Nine Mile Point Unit 1

License Amendment Request: Revision to Technical Specification Section 5.0,

**Design Features**

# PROPOSED TECHNICAL SPECIFICATION CHANGES (MARK-UP)

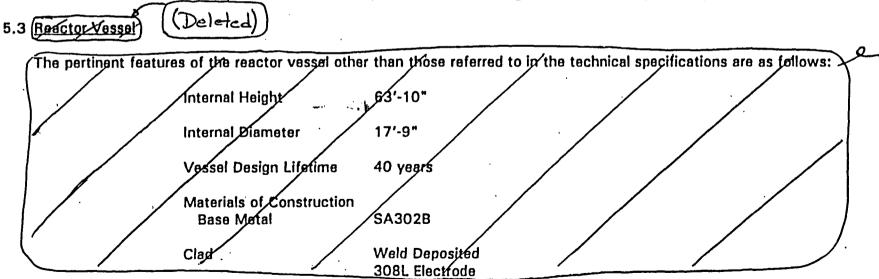
TS 5.3, "Reactor Vessel," lists certain design features of the reactor vessel, including the internal height, internal diameter, design lifetime, and materials of construction. The proposed changes relocate this information to UFSAR Section V-B.2.0, "Reactor Vessel," where the information already exists.

The reactor core consists of no more than 532 fuel assemblies containing enriched uranium dioxide pellets clad in Zircaloy-2. The core excess reactivity will be controlled by movable control rods and burnable poisons. The core will be cooled by circulation of water internally and external to the pressure vessel through recirculation loops.
